ADDENDUM #3

Project	Holy Family Catholic Elementary School	Project No.	2325
Location	1420 Grosvenor Street, Oakville, ON	Date of Issue	2024 04 09
Owner	Halton Catholic District School Board	File	2325/7.1.3

RE: Holy Family Catholic Elementary School
Renovations
Oakville, ON

ADDENDUM 02

Drawing Title
GROUND FLOOR PLAN DEMOLITION PHASE 1
 Scale: AS NOTED
 Drawn by: CP
 Job No: **2325**
 Date:
 Checked by: MEK
 Drawing No: **E21**

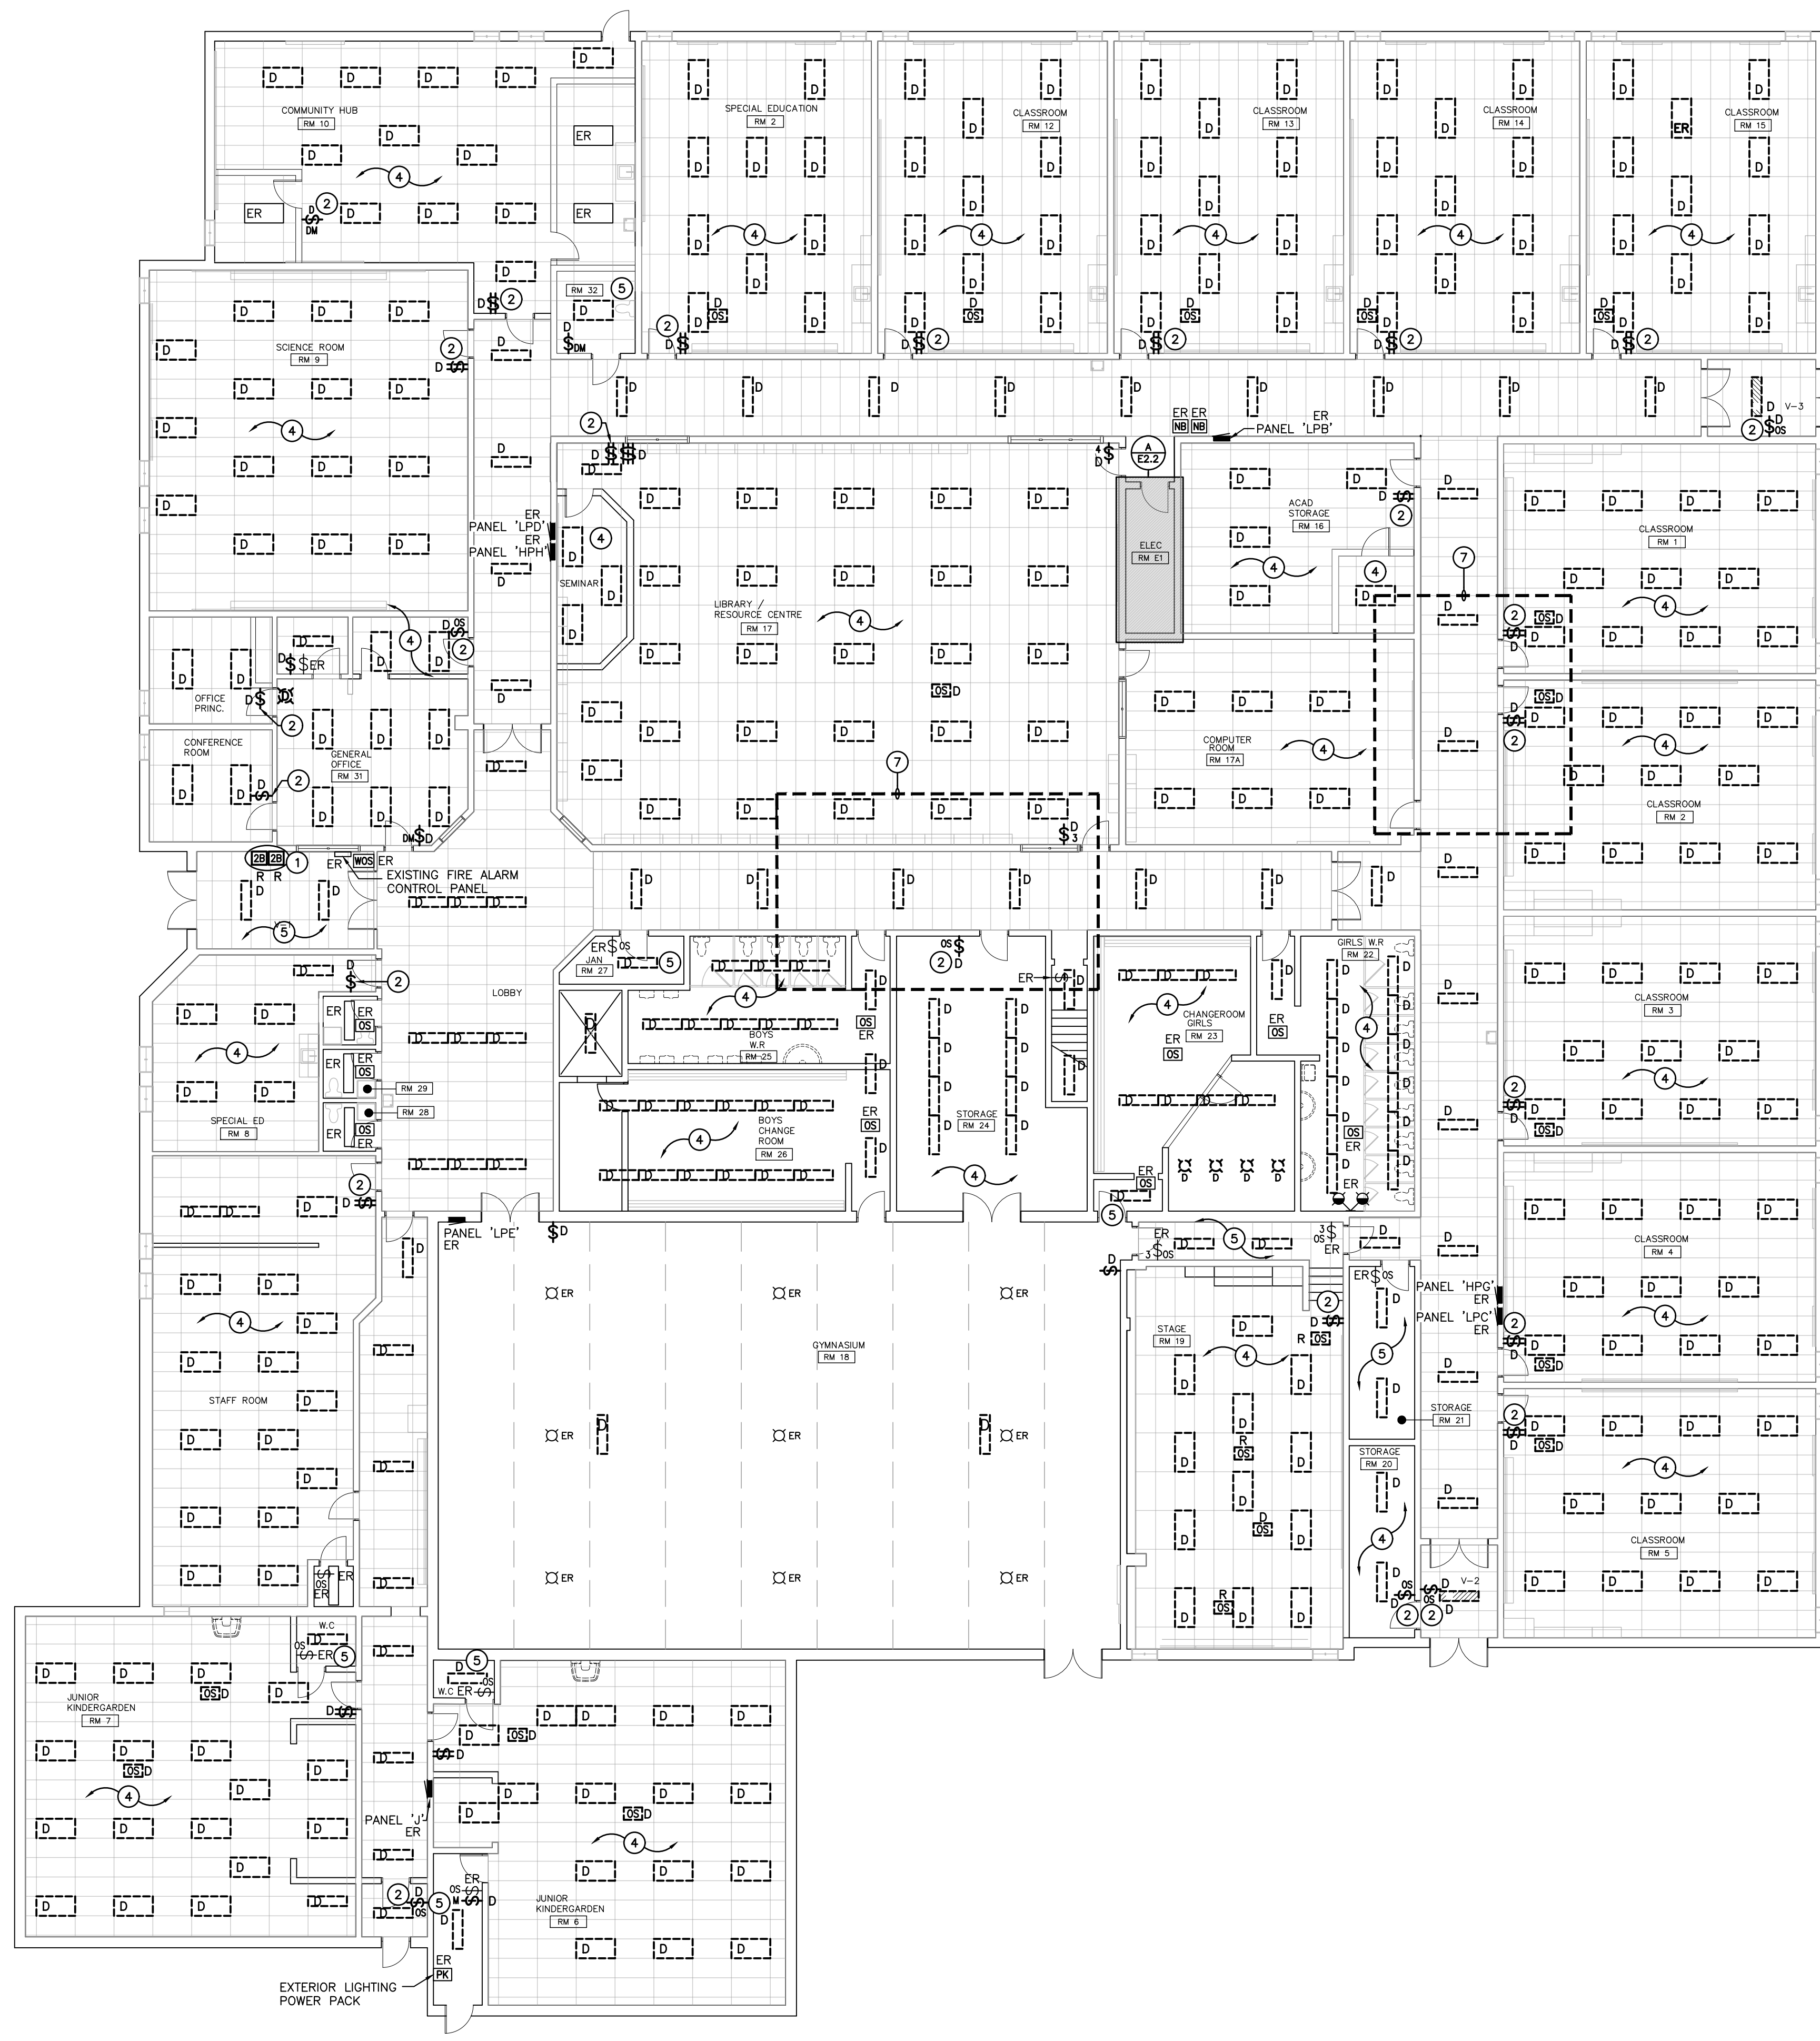
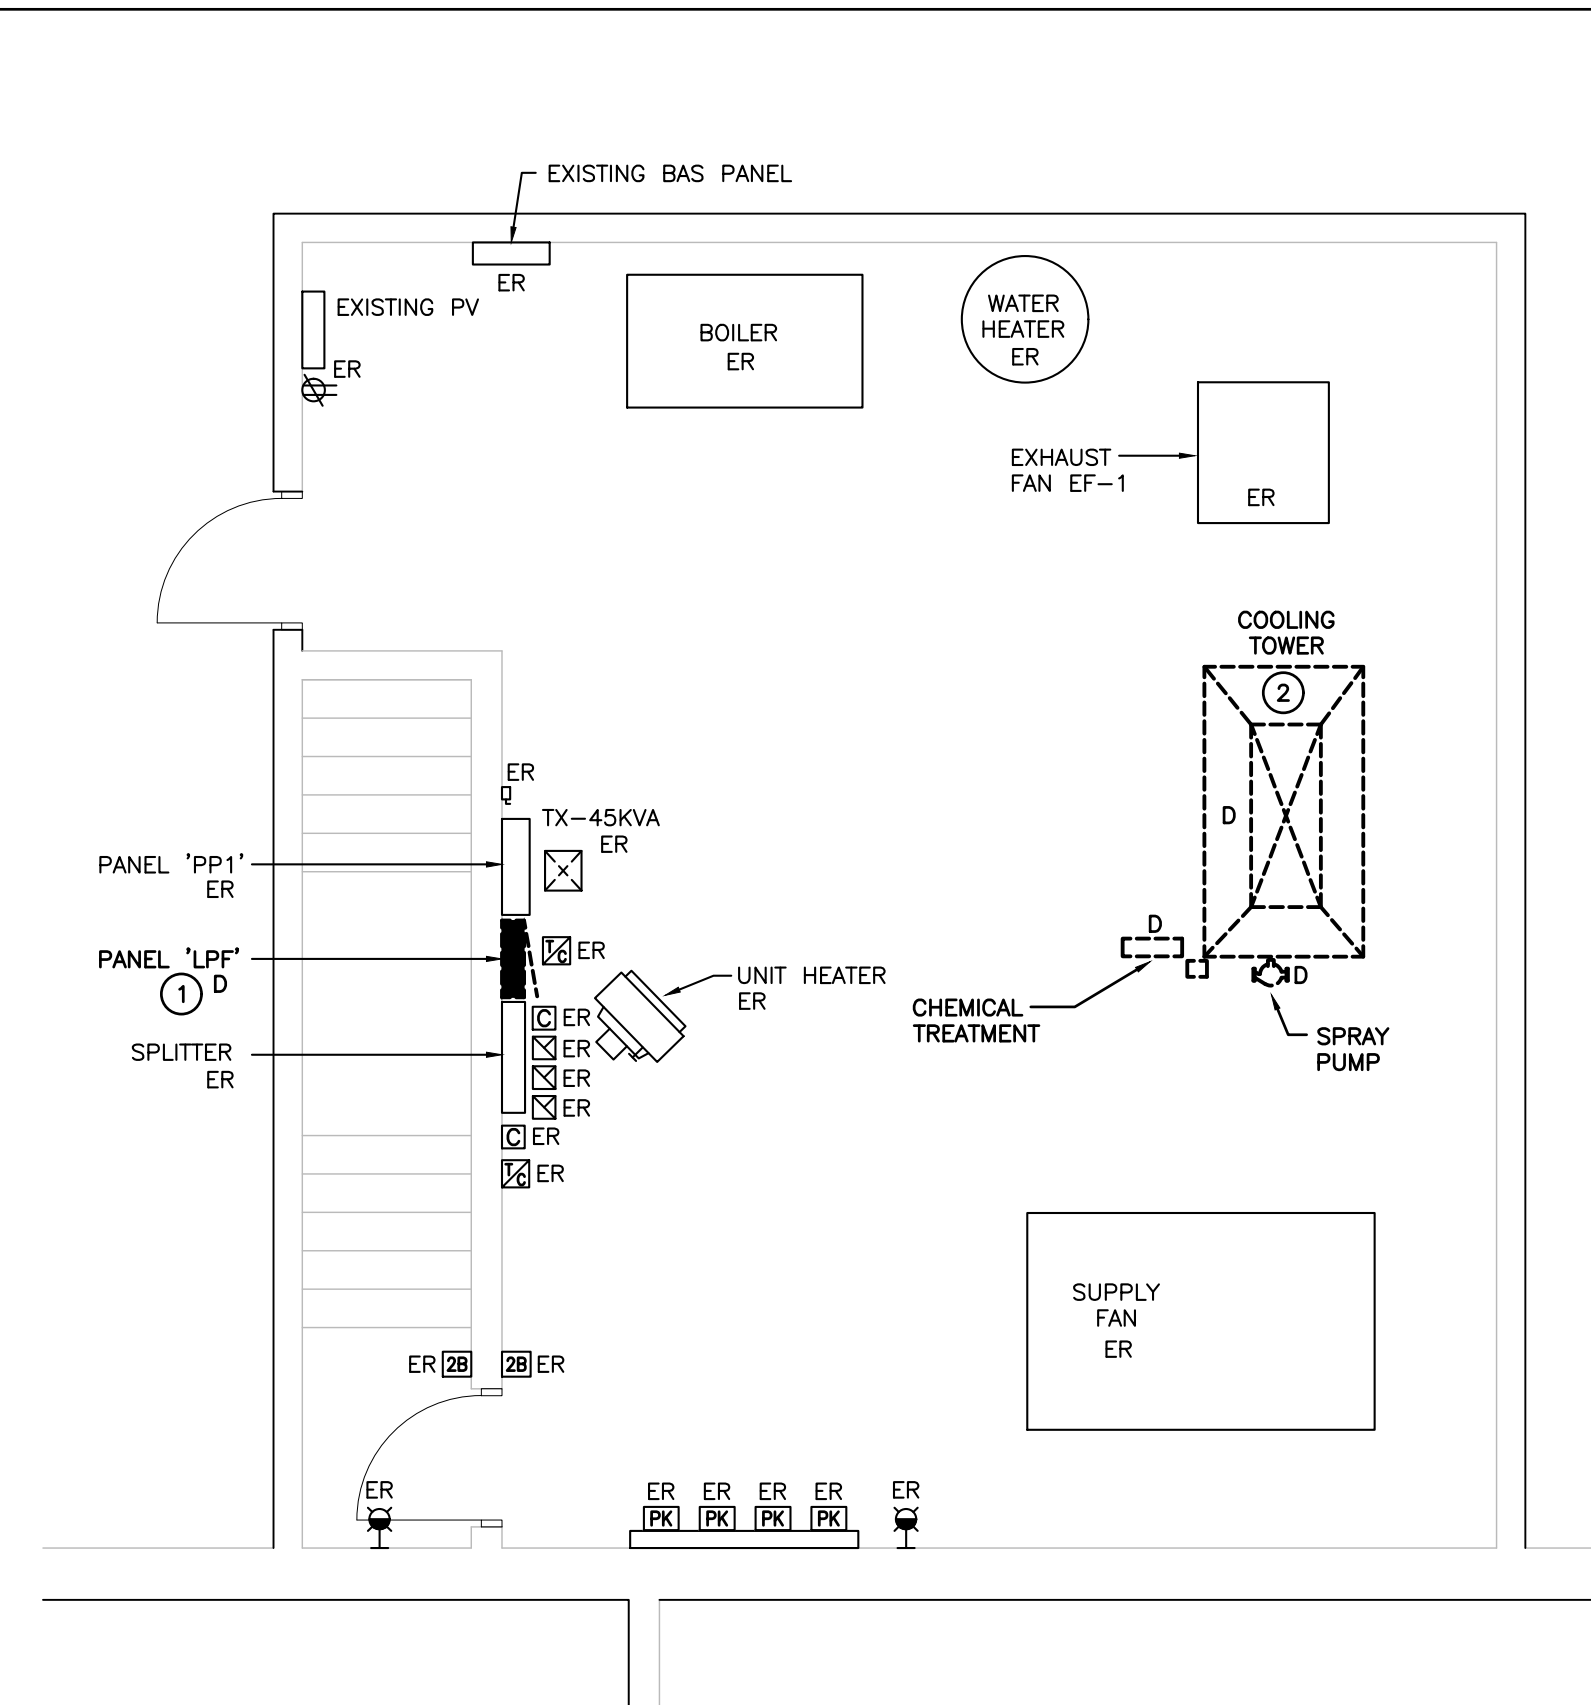
5.0 Reference Attached Reissued Drawing E2.1
.1 Revise note 3 as shown.

Drawing Title: **GROUND FLOOR PLAN DEMOLITION PHASE 2**
 Scale: AS NOTED
 Date:
 Drawn by: CP
 Checked by: MEK
 Job No.: **2325**
 Drawing No.: **E22**

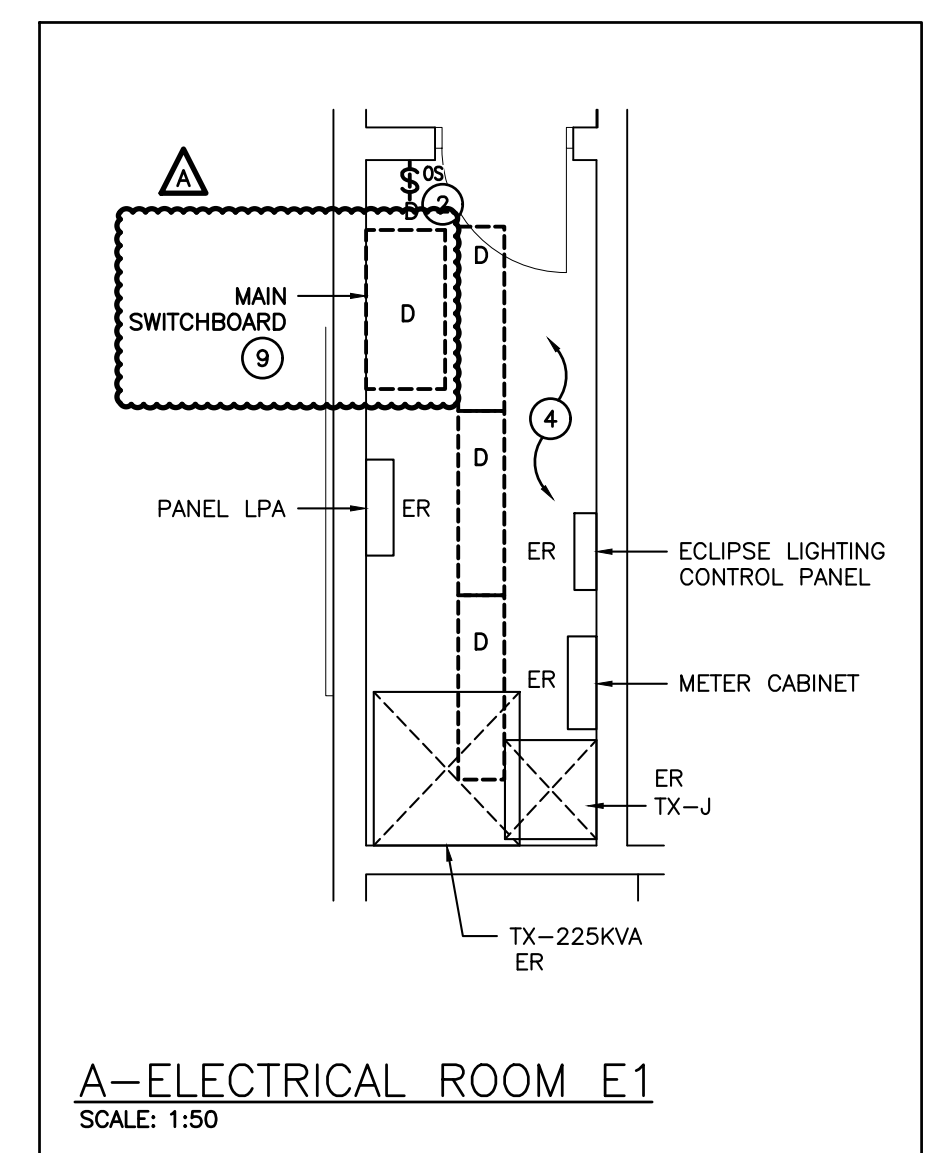
6.0 Reference Attached Reissued Drawing E2.2
.1 Whole main switchboard shall be demolished instead of just main fuse disconnect switch and branch circuit breakers. Revise note 9 as shown.

- INDICATES MAIN SWITCHBOARD TO BE DISCONNECTED AND REMOVED COMPLETE. MAINTAIN EXISTING BRANCH FEEDERS FOR RECONNECTION TO NEW MAIN SWITCHBOARD AS SHOWN ON RENOVATION PLAN. REFER TO DISTRIBUTION RISER DIAGRAM FOR ADDITIONAL INFORMATION.
